Access Compliance Report

Public Rights-of-Way

(Curb Ramps)

Intersection ID: N/A	Main Street: ALBERMARLE RD	Cross Street: CIRCUMFERENTIAL RD	Location: NE
ADA ID: 23AF15E52735	Ramp Type: ParaDiag	Initial Pass/Fail: Pass	Overall Compliance: No
		Severity Score: 0

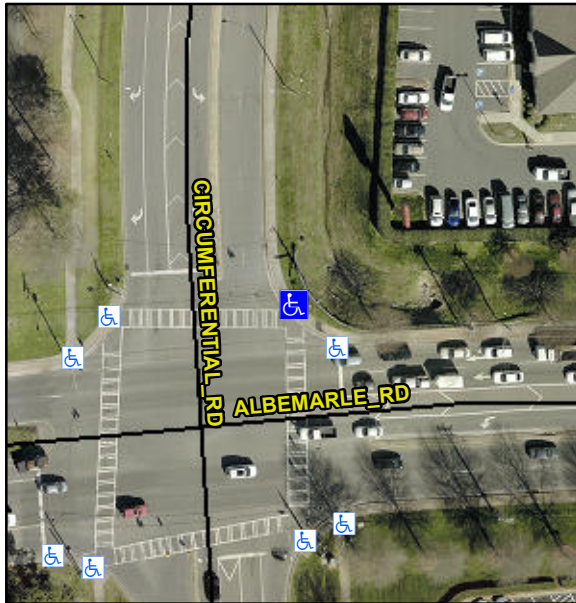
Possible Solutions:

Remove & Replace Landing.

PROW/ADA:

R304.2.2-Perp, R304.3.2-Para
